**DOCKET NO.:** 980946 - TL

DESCRIPTION: FPSC (LEG/B.Keating) -  
(CONFIDENTIAL) Exhibits K LW-1 through K LW-4  
to Kathy L. Welch's direct testimony. [RAR 5/12/99  
note: Based on DN 06056-99, certain pages were  
pulled from this document and moved to docket file.

INVESTIGATION OF COLLOCATION SPACE WAIVERS

BOCA TEECA OFFICE

39280 LAKE MARY FIRST FLOOR F

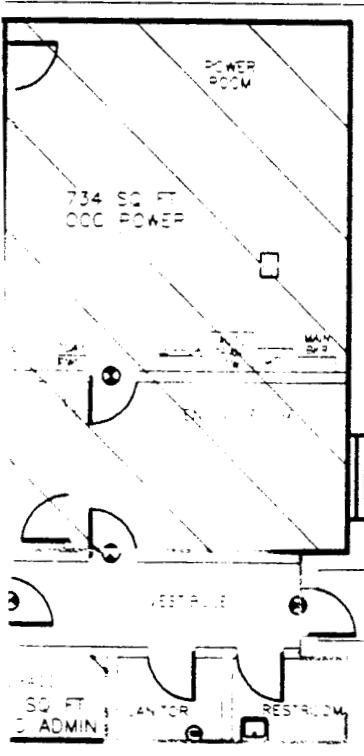
**AUDIT DISCLOSURE NO. 6****SUBJECT: LAKE MARY AREA 1**

**STATEMENT OF FACTS:** Area 1 is currently a contractors office and a monitoring station for the switch access computer. The space is approximately 8' by 9' and is located next to the switch equipment on an isolated ground plane (See disclosure 1 for discussion). It cannot be moved to the outside wall because of the fire aisle needed from the power room. Whether this space could be used or not is contingent on whether a space that is less than 100 square feet can be used for collocation. A common area would have to be placed in another location in the office. The company representatives stated that existing agreements require a minimum of 100 square feet. It would not be accessible without an escort. Lastly it is contingent upon whether the company has to relocate existing items in the office. (See disclosure 1, Item 7)
